Centre Plan Package A | Feedback Past Deadline Submissions

(Post May 8, 2018)

Centre Plan Review

Modelling select lots using draft Centre Plan Provisions

Gottingen Street (between Cornwallis and Cunard)

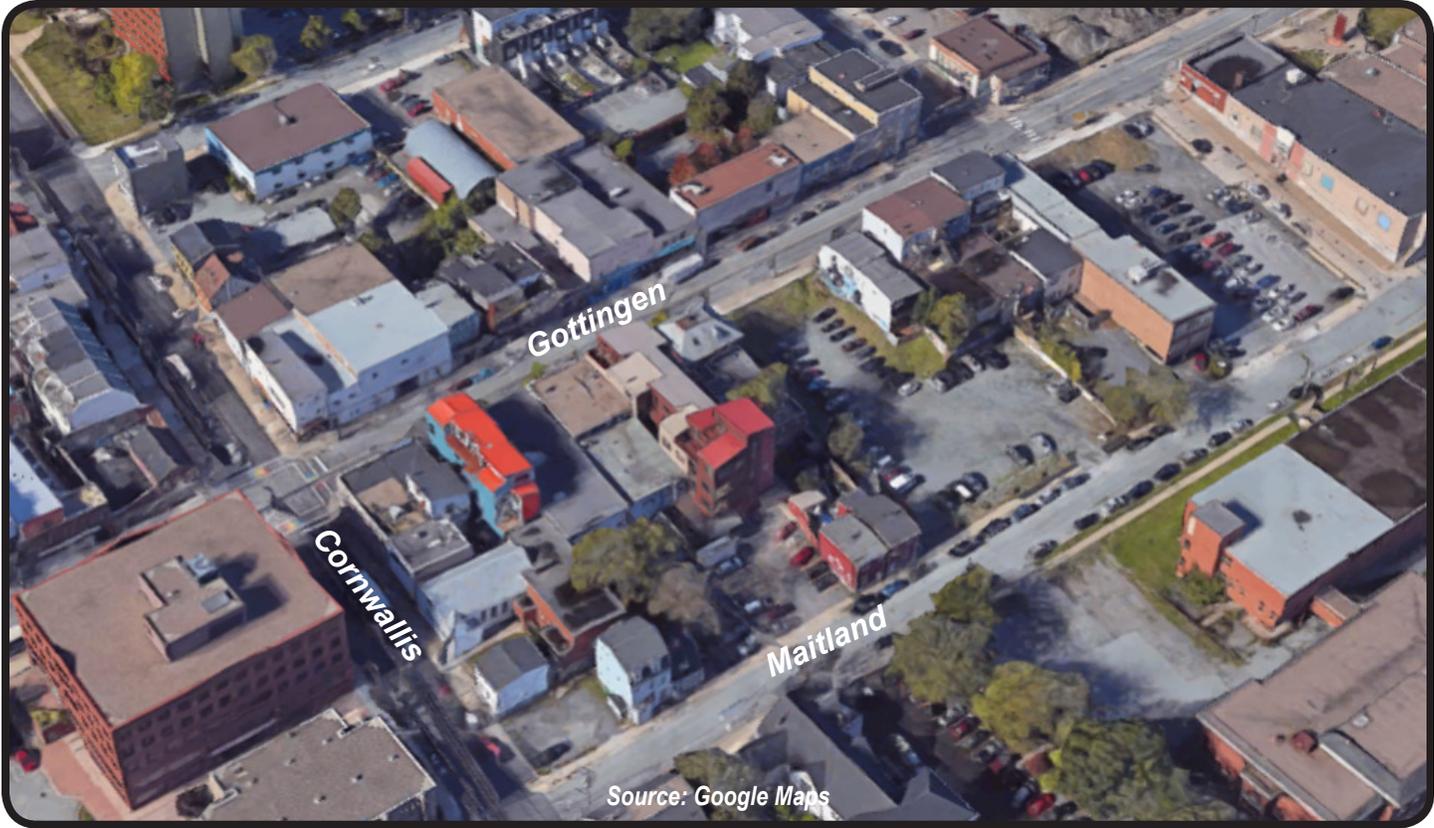
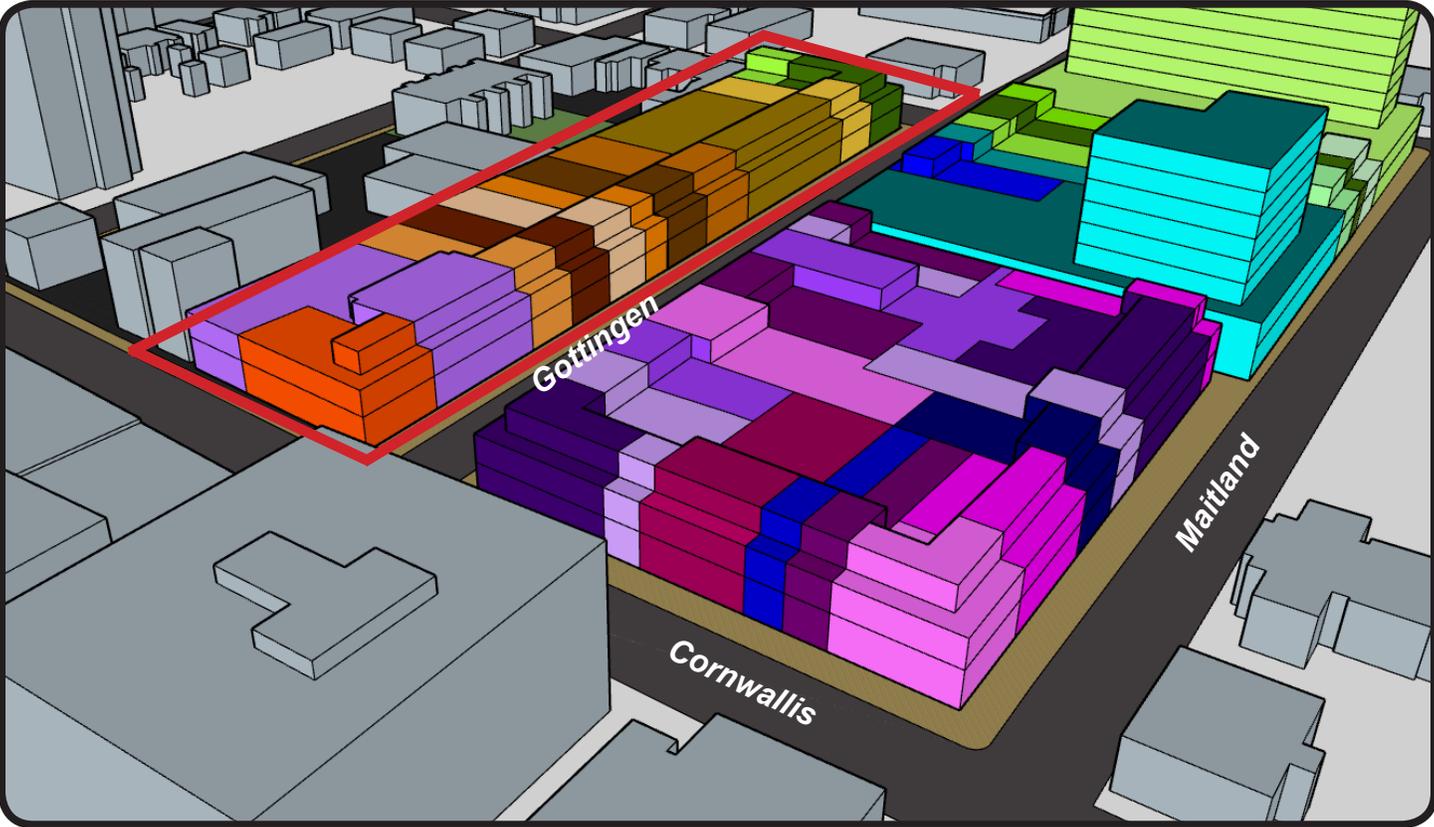
There were several things that are being recommended for change on this stretch of Gottingen. Firstly, the required 4.5m ground floor height should be reduced to about 3.75m. The streetline yard should also be limited to 1m.

The height that is permitted should be 17m (to reflect 5 storeys). The streetwall height could also be reconsidered here to reflect the existing 3-4 storey streetwall. In general, the feeling is that the zoning provisions for the area that currently exist should be retained to an extent.

The GFAR has greatly restricted redevelopment of individual lots. On lots where full coverage is permitted, a GFAR of 2.25 doesn't allow for buildings of a similar size to those that exist already. Gottingen could benefit from a slightly higher GFAR to allow for more feasible developments on smaller lots, which make up most of the street.

Gottingen Street (between Cornwallis and Prince William)

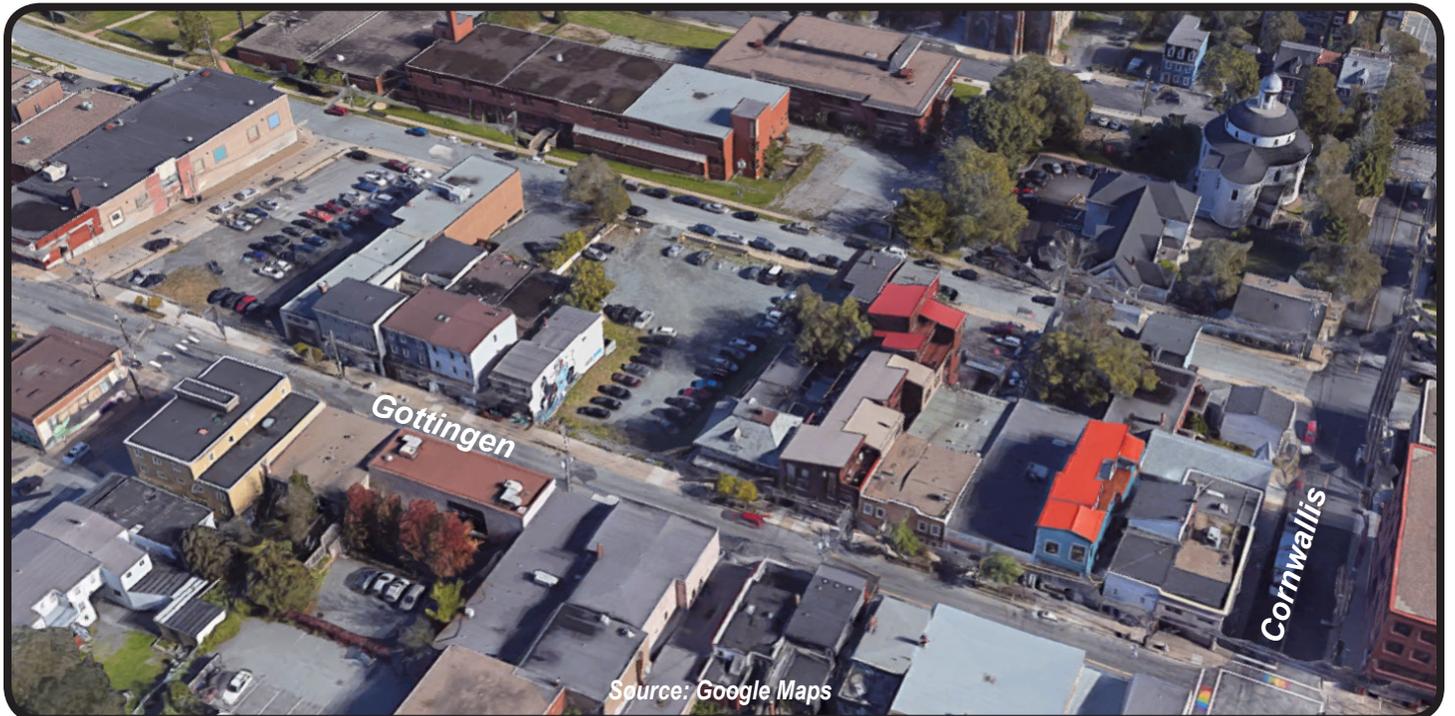
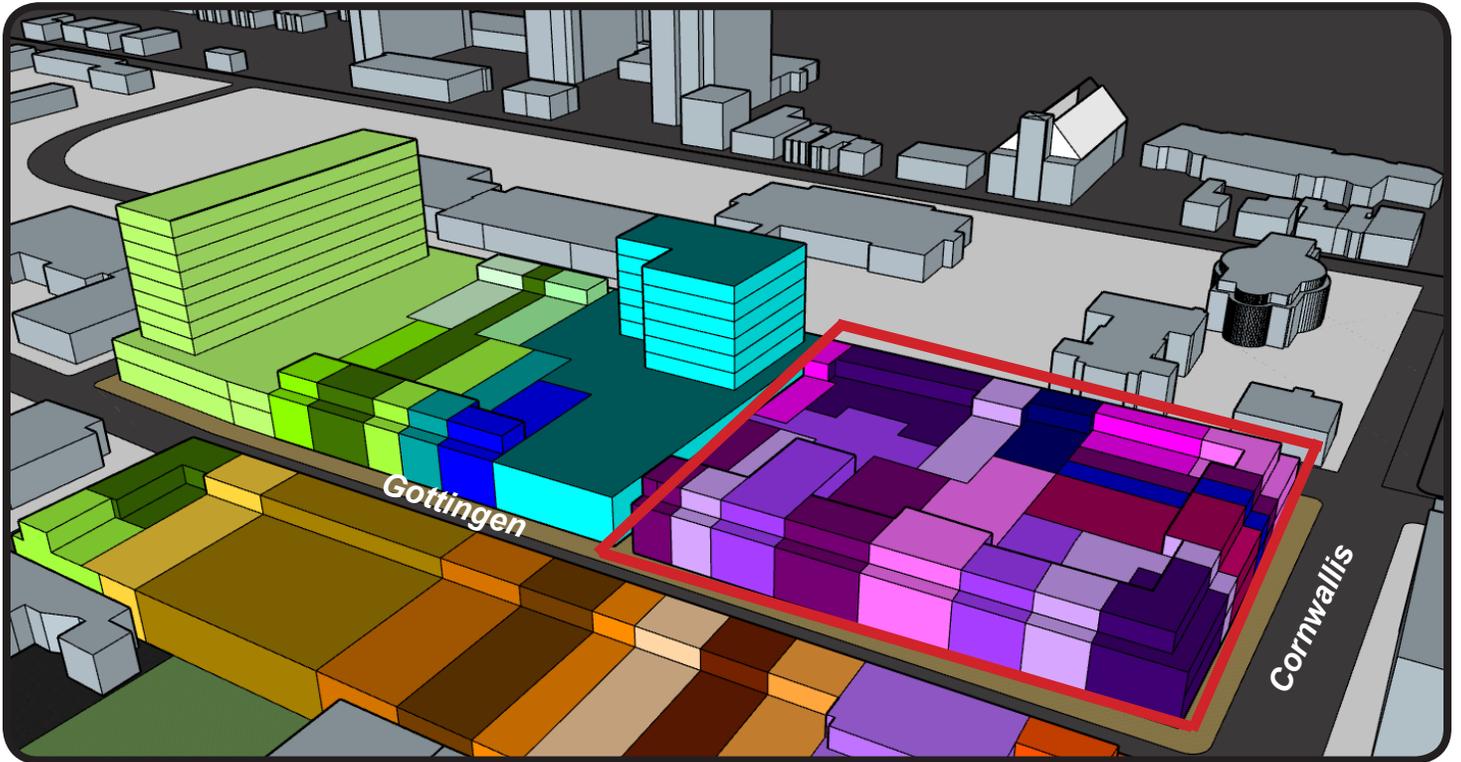
This side of the street has the same concerns as on page 12. This side of the street simply has more diversity in terms of height limits and GFARs. The main concern would be the 2.25 GFAR for the buildings to the south of this block (in pink/purple). This means new buildings would actually be smaller than what currently exists or is allowed on many of the lots.

Agricola between Cunard and Sarah

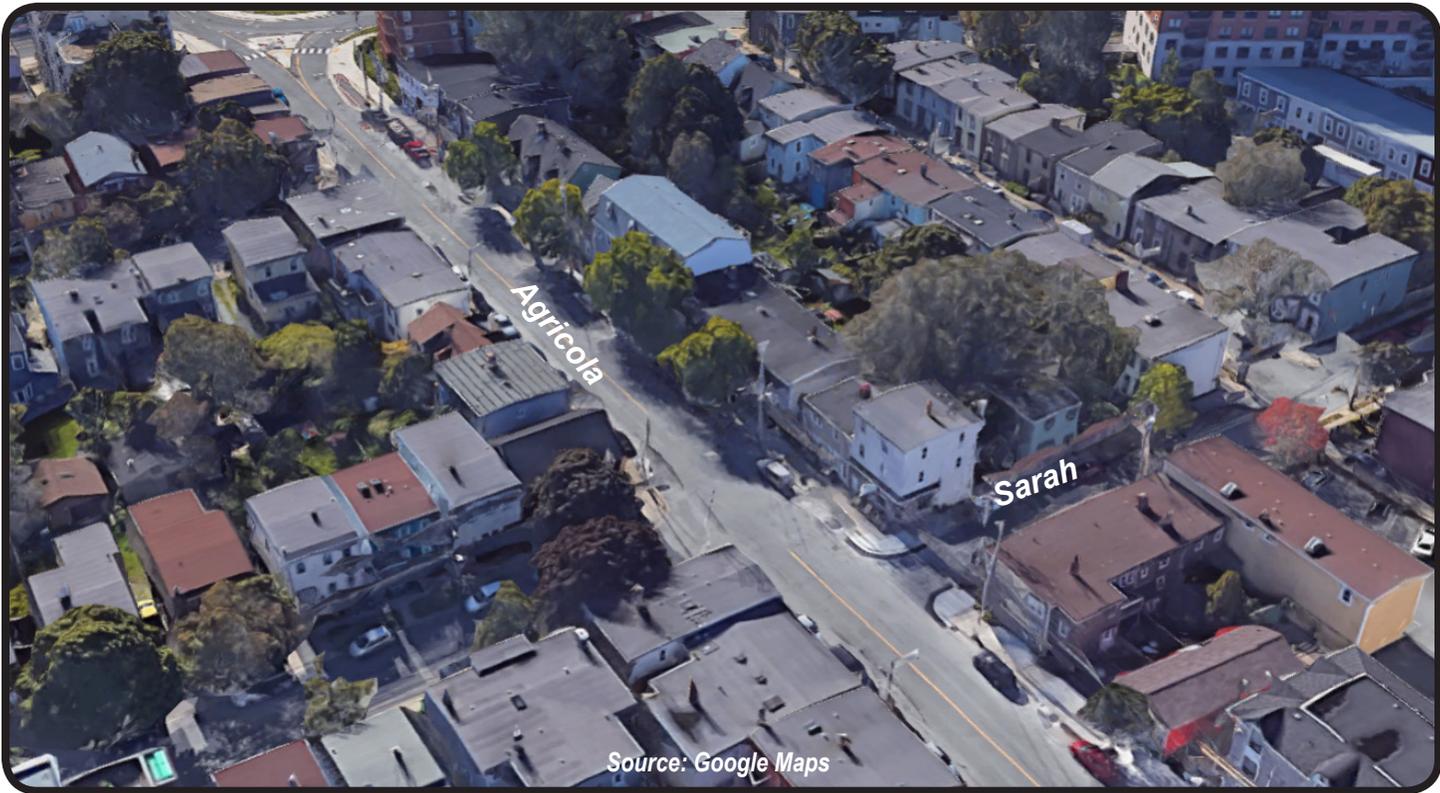
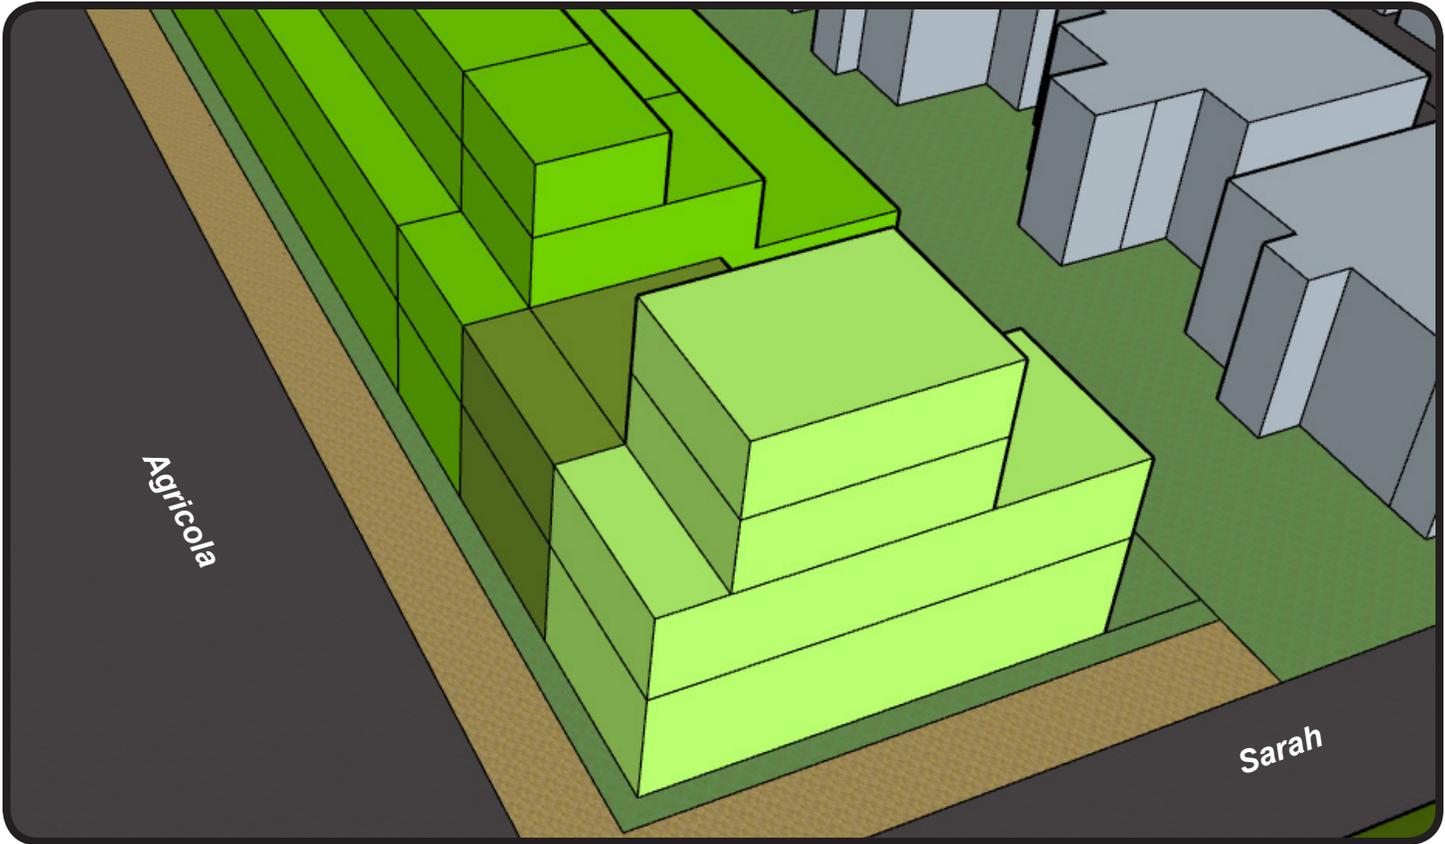
Agricola is one of the better preserved commercial streets in the city of Halifax. There is concern that the new zoning provisions being proposed for the street may detract from the overall character.

It is suggested that a Retail Formula Ordinance be established on Agricola in order to retain the local character, without necessarily restricting larger chains from establishing themselves here.

One advantage that many buildings on Agricola have is that they have a larger building footprint than what would be allowed under the new provisions meaning, in some cases, renovating buildings would be more attractive than tearing down and building new.

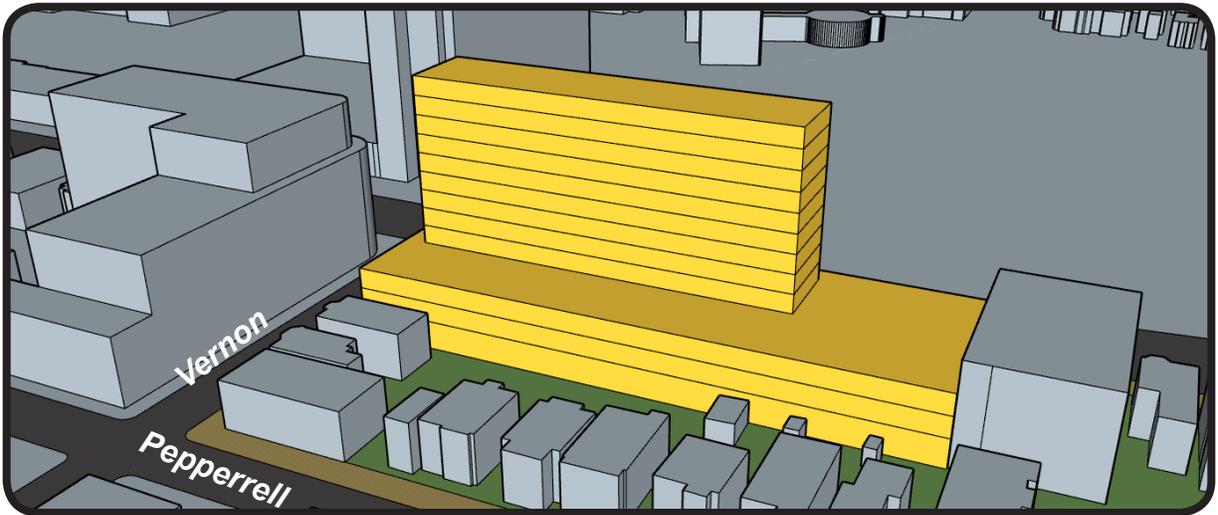
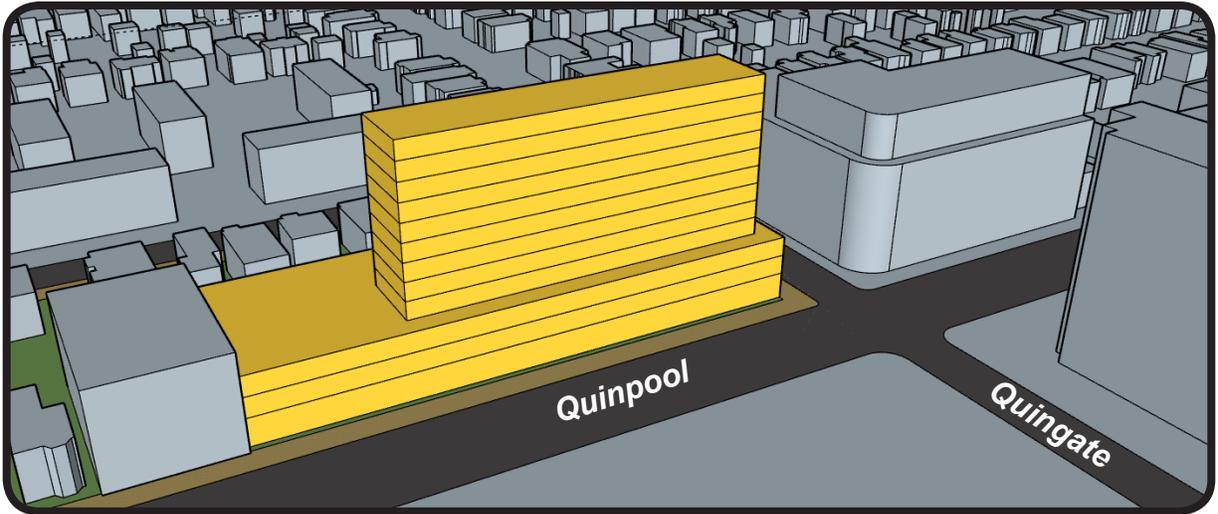
This area was modelled to demonstrate the number of lots would be required to achieve the height and GFAR outlined in the Centre Plan, while also achieving a viable building envelope. Based on high-rise provisions, there needs to be 12.5m setback from interior lot lines for the portion of the building above the streetwall height. Because of this, about 6 lots (at 9-10 metres wide) would be required to achieve both height and GFAR permitted in the Centre Plan. The modelled high-rise assumes that the 7 lots along Quinpool east of Vernon have been consolidated.
